ISSUE: Permit to Demolish and Certificate of Appropriateness for New Construction

APPLICANT: Eleventh Street Development, LLC

LOCATION: Old and Historic Alexandria District
101 Duke Street

Minutes from the October 6, 2021 BAR Hearing

Figure 3: Detail at vertical notch in exterior wall

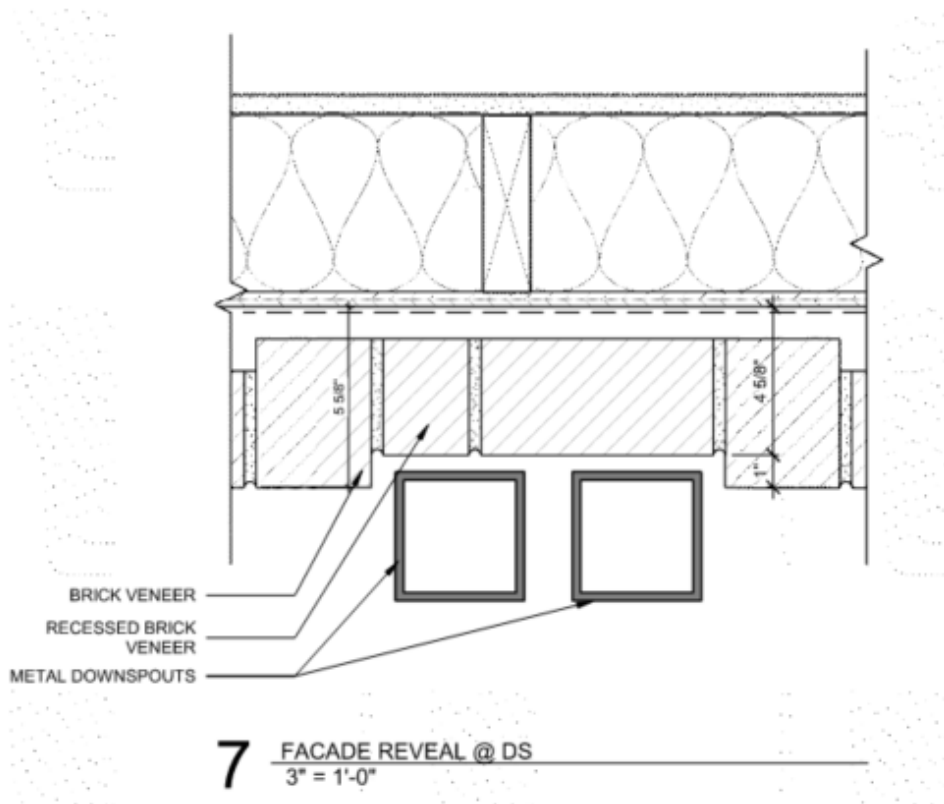
One of the staff comments related to the previous submission was a recommendation that the applicant create a vertical reveal in the brick at the west elevation between each townhouse unit to accommodate the proposed downspouts. During the October 6, 2021, hearing the Board agreed with this recommendation. In response to these comments, the applicant is proposing a vertical notch in the brick at each of these locations with square downspouts located within the notch (Figure 3).

The introduction of the notch at the rear of the building to accommodate the downspouts is a subtle but effective design element that helps to give order and hierarchy to the elevation. By gathering these necessary building elements into an intentional architectural feature, they become a part of the building architecture rather than a purely pragmatic building component. Staff finds that this modification addresses the comments from staff and the Board.

Figure 7: Brick stoop (left) and metal stoop (right)

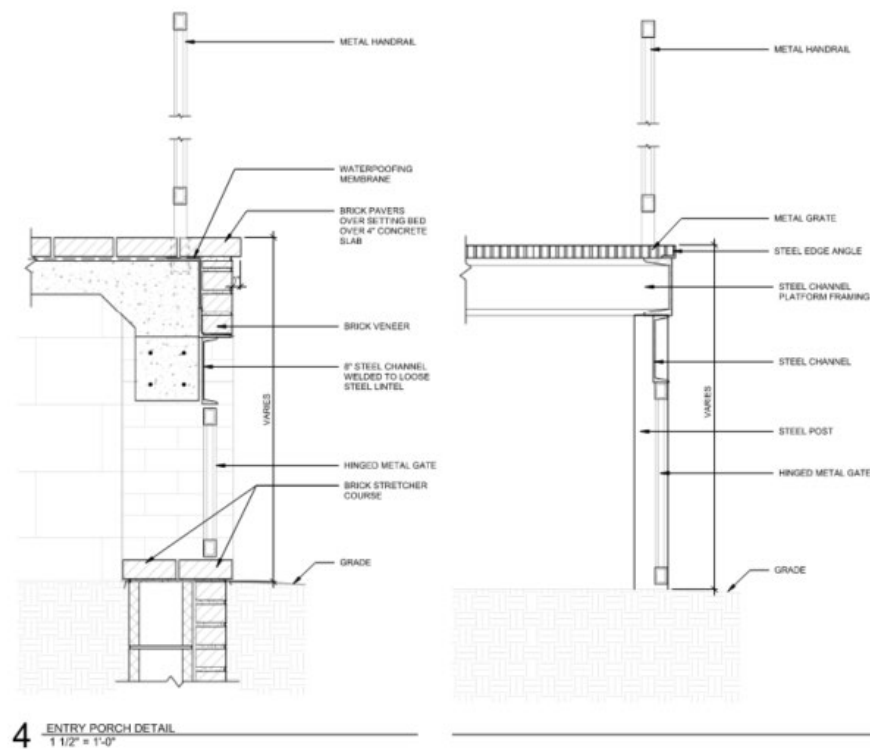
The previous design included brick stoops at the south building and a combination of brick and metal stoops at the north building. In response to comments from the Board, the applicant has modified the design for the north building to include stoops that are all metal (Figure 7). The use of metal stoops on the north building is reflective of the greater articulation of muntins on that building. The use of brick stoops on the south building helps to ground the building and is compatible with the more horizontal proportions. Entirely metal and entirely brick stoops are commonly found throughout the historic district. This design modification echoes architectural details found within the district while being compatible with the language of each building. Staff finds that this modification successfully addresses the comment from the Board and results in a building that is referential to historic architectural components while being clearly modern. Staff recommends that the applicant work with staff on the final construction detailing for the stoops.

1. The applicant work with staff on the final details for the entry stoops on Union Street.

HEIGHT EXHIBIT

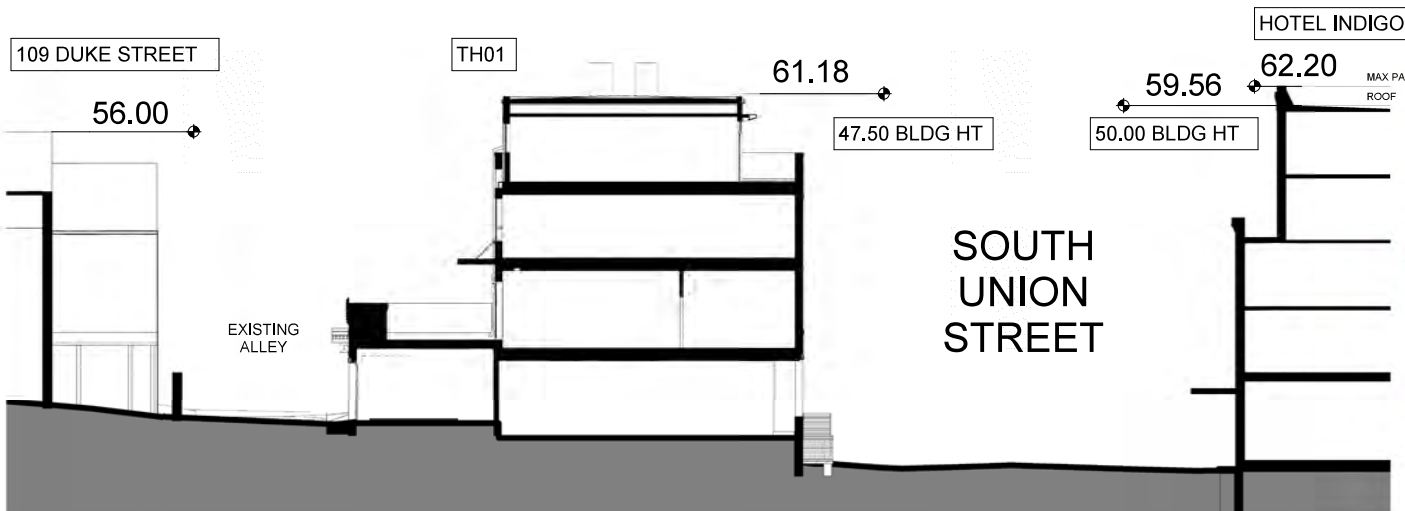
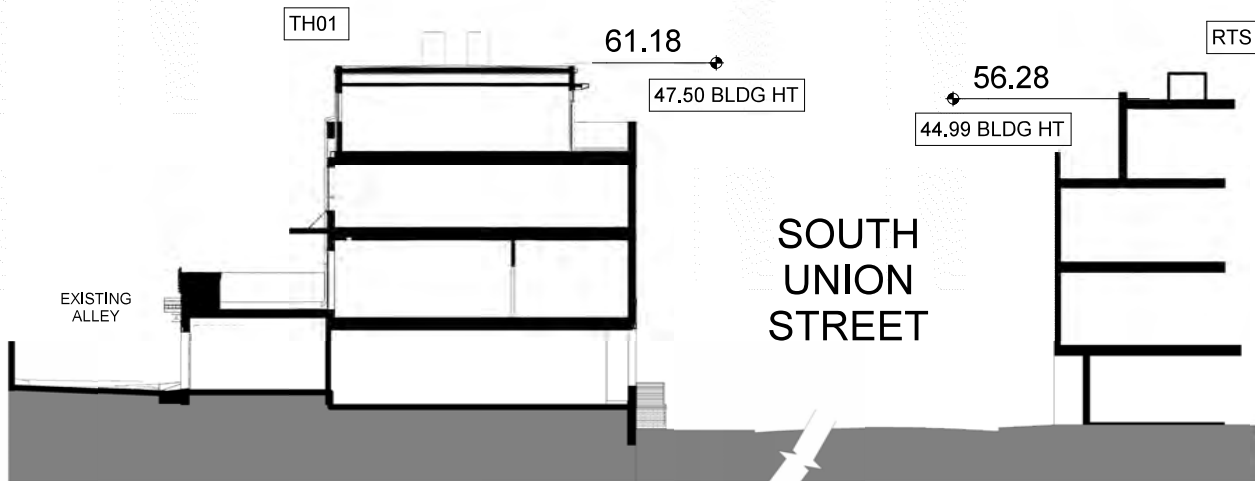
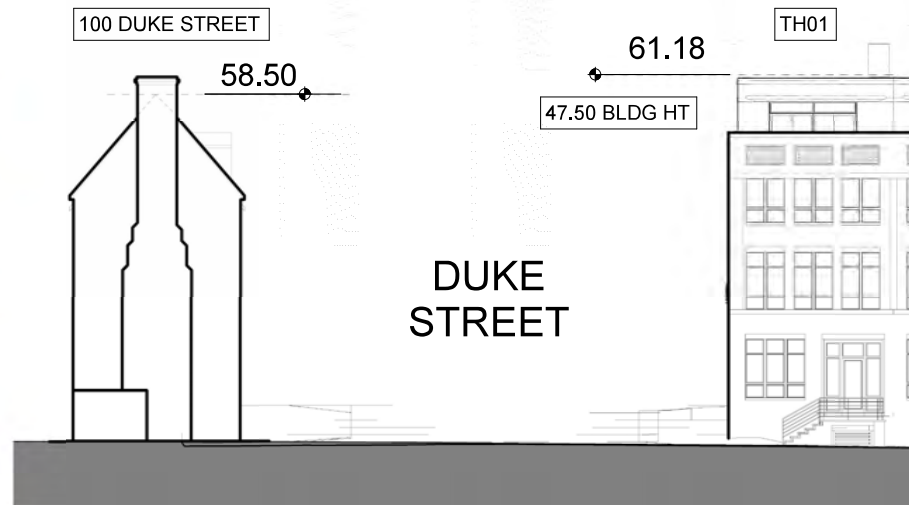
Ms. Roberts asked how the height of the proposed building compares to the height of the neighbors. The applicant responded that the proposed building will be approximately five feet taller than the building across Duke Street.

3. Finally, can you please specify which part of the building you are measuring as the top of the building vs. 100 Duke Street given drastic inconsistencies? For example, the image shown by Ken Wire (first time I am seeing these diagrams) erroneously compares the height of the chimney on 100 Duke Street to the "top of the proposed building," using different vantage points of comparison. Moreover, please note the differences in elevation in question #2 are not taken into account in the drawings' height measurements. It's evident that the drawings shown tonight are not accurately scaled, making the proposed building look less prominent than in reality.

Mr. Wire described the different height measurements provided, indicating that zoning measures from average finish grade which can be different than the perceived heights.
